MEMORANDUM

SUBJECT: 9 Emerald Lane – Tree Removal/Planting Plan
Tax Map 48.08-1-36;

DATE: March 6, 2025

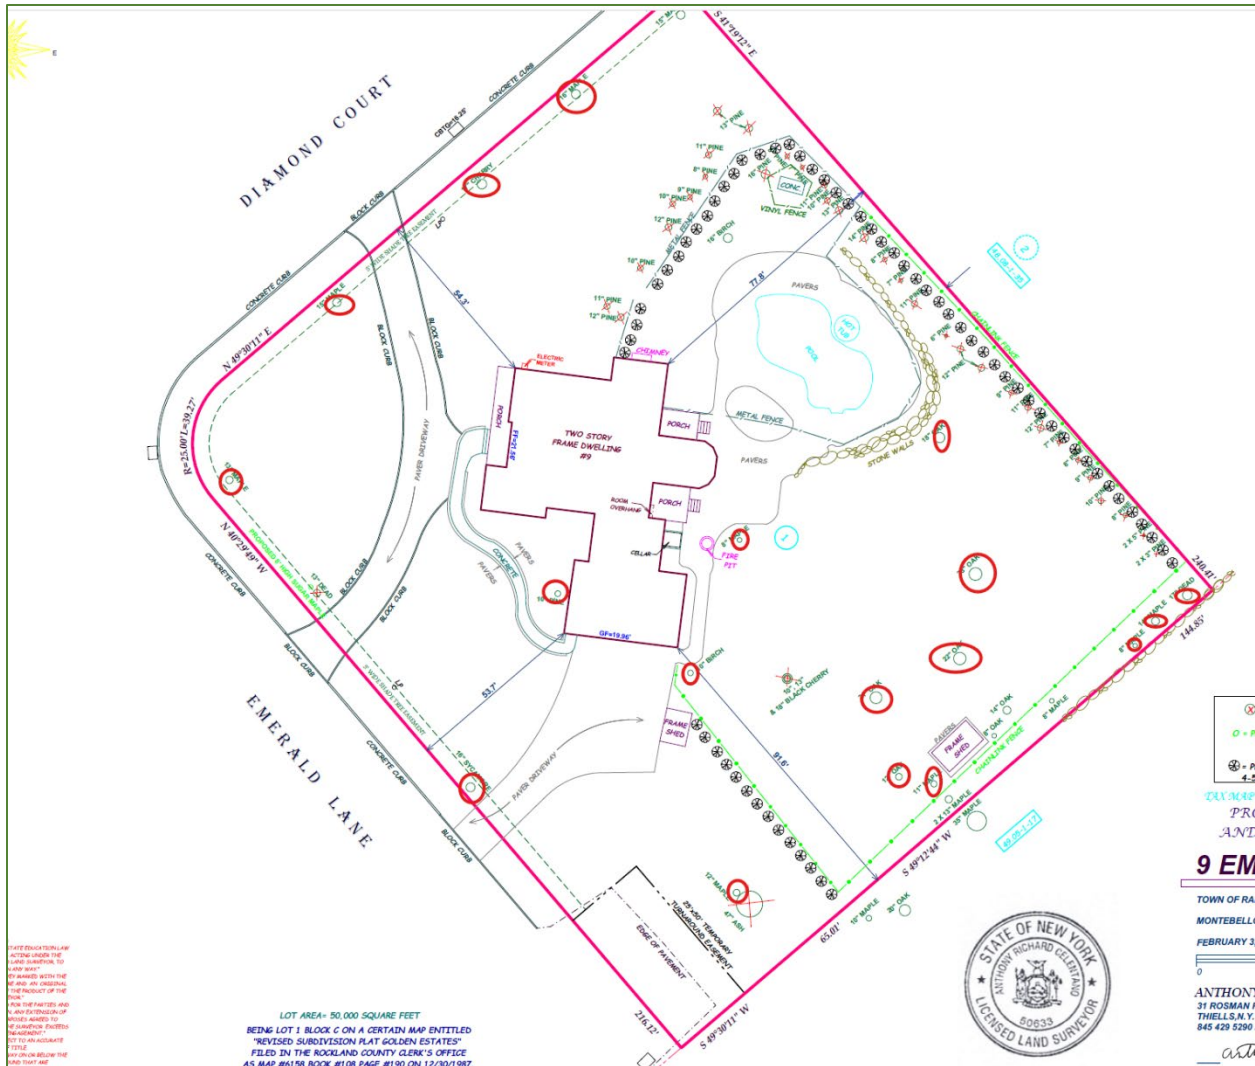
1. Please clarify the details of the proposed 8-foot-tall sugar maple tree, indicated on the Celentano Plan. A label for the new tree is shown on the left side of the Emerald Lane driveway entrance, but no bright green circle is indicated to show where the trunk of the tree will be located. The proposed sugar maple also is not mentioned in the project narrative by Mr. Fromowitz. **Please**

confirm if this sugar maple tree is part of the proposal, and if so, it should be reflected in the narrative submission, and its specific location should be shown on the landscape plan.

2. In our diagram below, please note that there are several trees throughout the site circled in red that appear to be existing trees. Please provide a distinct symbol for the existing trees and include them in the legend.

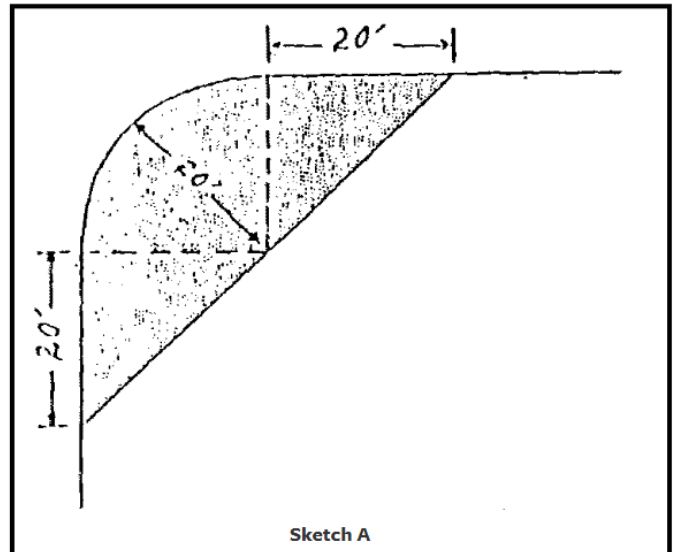
5. Please that the location of the proposed 8' high sugar maple conforms to the standards set forth in §160-23, which states: "No shrubbery, hedge or other natural growth, or fence (except a transparent fence such as chicken wire, in which the solid area is not more than 5% of the total area of the fence) or wall over three feet higher than the apex at the center line or the street shall be located within the triangular area shown shaded in Sketch A at the intersection of two roads: (See right.)

Nor shall the limbs or foliage on any tree obstruct vision or be permitted to grow nearer to the ground than eight feet where such limbs or foliage overhang or are over or upon land within the triangular area as shown in Sketch A."
